Notice of Allowability

10/791,581

LIANG, GEORGE

FIG. 2

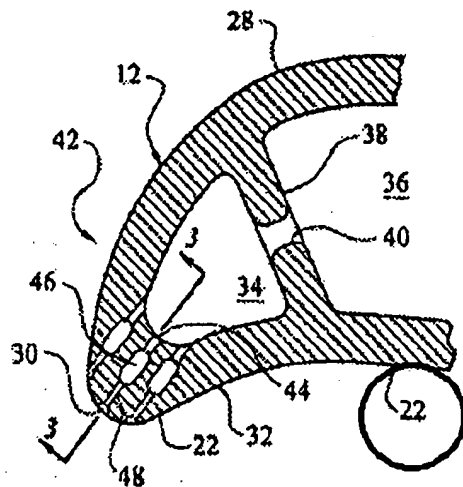
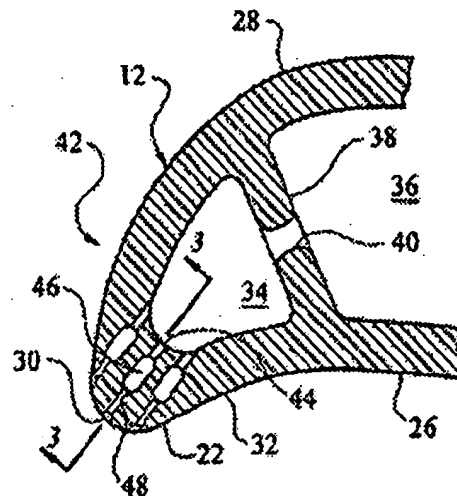
The numeral "22" in Fig. 2 should be -- 26 --. See reproduced figures below wherein the drawing on the left identifies the error and the drawing on the right shows the correction. In order to avoid abandonment of the application, applicant must make this drawing change.
